Category <b>R</b>	<b>Repair Guidance</b>	Ref. No. R025/13B	Page 1 of 2
Coverage <input type="checkbox"/> Distributor only <input checked="" type="checkbox"/> Please inform your dealers		Date Issued March 25, 2013	
Please convey this information to your <input type="checkbox"/> Director <input checked="" type="checkbox"/> General Manager <input checked="" type="checkbox"/> Warranty Dept. <input checked="" type="checkbox"/> Parts Dept. <input checked="" type="checkbox"/> Training Dept. <input checked="" type="checkbox"/> Field Rep.		Date Revised May 21, 2013	
Applicable Model  CX-5 (KE)		Applicable Countries or Specifications  Worldwide

## Subject: Knocking/Squeaking Noise from Front Strut Bearing

[Front shock absorber and coil spring]

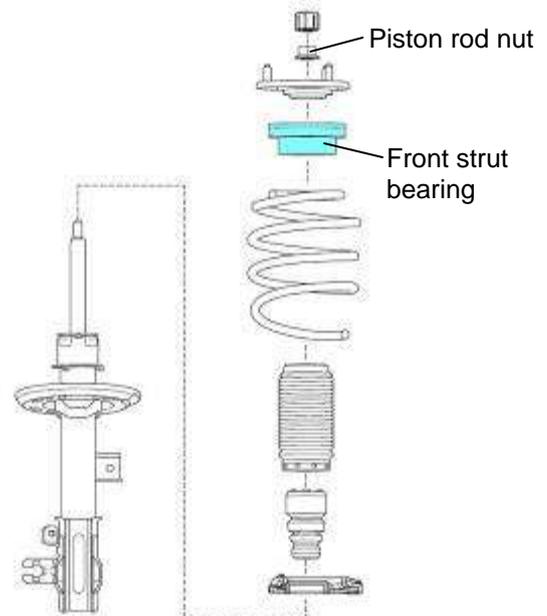
The noise may occur due to the upper housing of the front strut bearing being damaged **when applying excessive force to the bearing during customer's usage**.

Material and forming method of the front strut bearing have been changed.

Replace the damaged strut bearing with modified one according to the Workshop Manual. Refer to [FRONT SHOCK ABSORBER AND COIL SPRING DISASSEMBLY/ASSEMBLY].
